GRADING AND DRAINAGE PLAN

SONIC DRIVE-IN RESTAURANT

RE: DRAINAGE PLAN FOR SONIC DRIVE-IN @ 4803 CENTRAL AVENUE, NW
(K-12/D19) RECEIVED FEBRUARY 25, 1988

GRADING & DRAINAGE PLAN
SONIC DRIVE-IN
4803 CENTRAL AVE. WEST

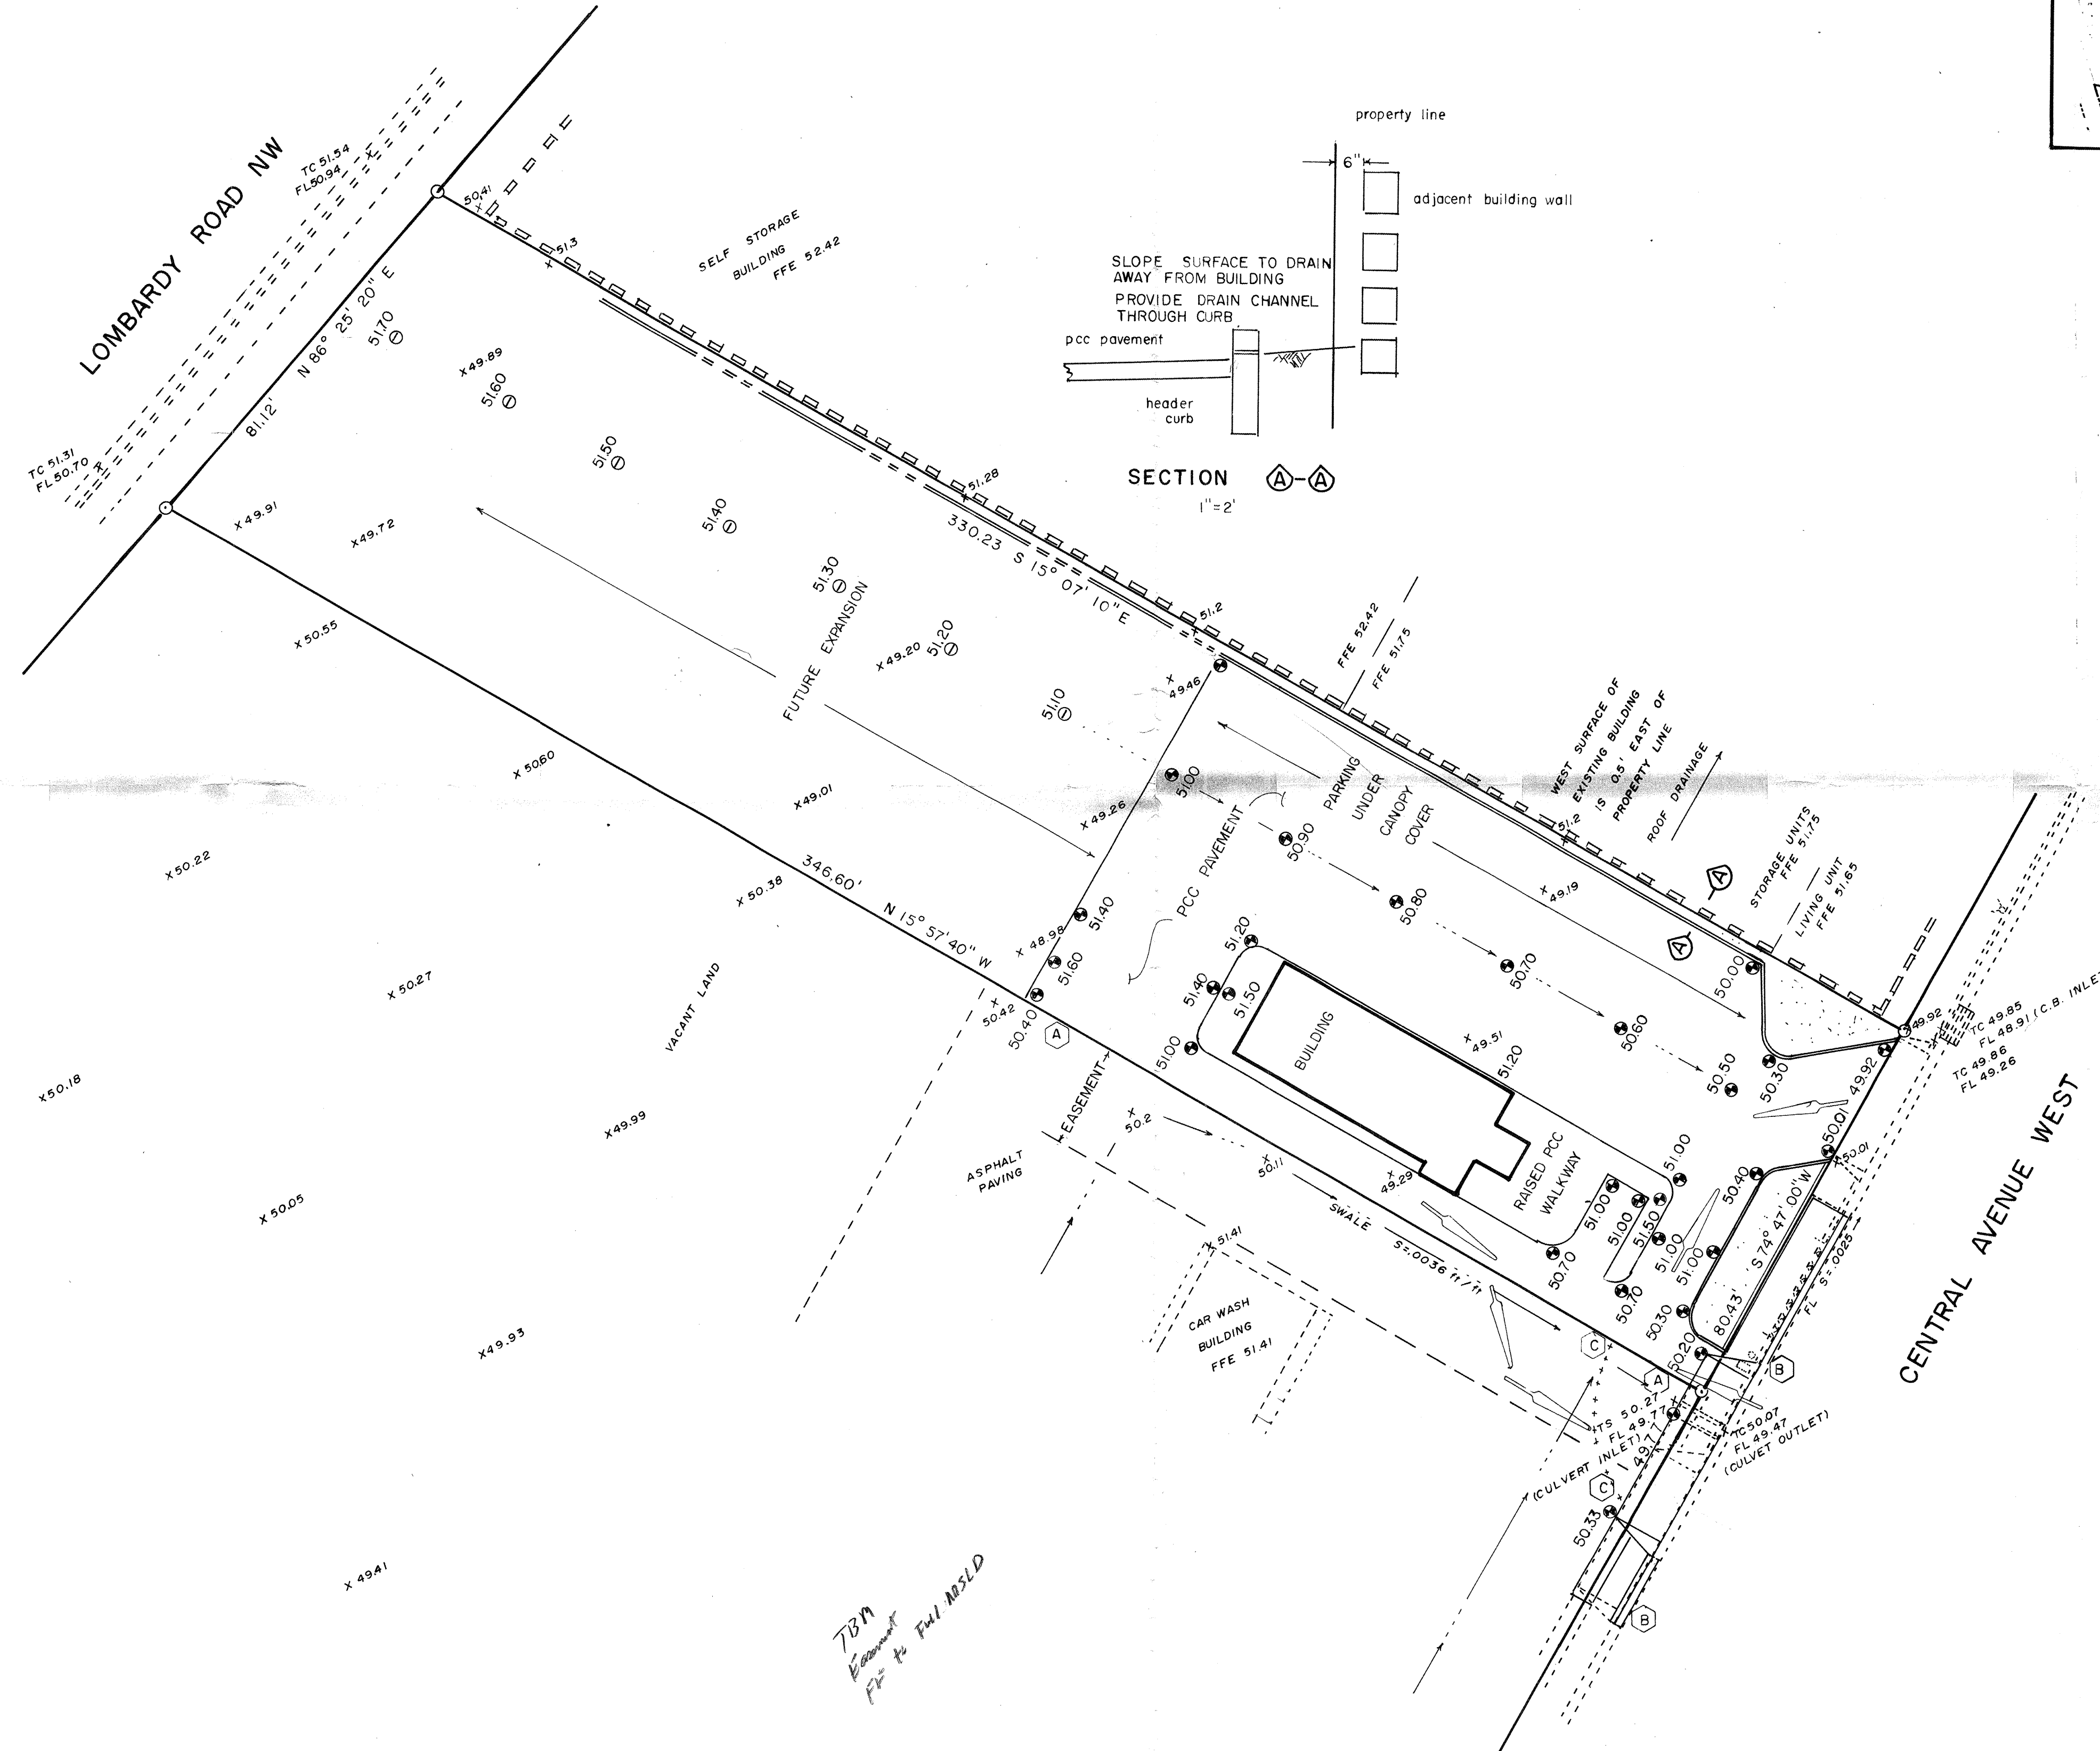
1. Location, description, and elevation of T.B.M.
2. Finish floor elevation to full mean sea level designation.
3. Note identifying that a separate submittal will be required when the northern portion is developed.
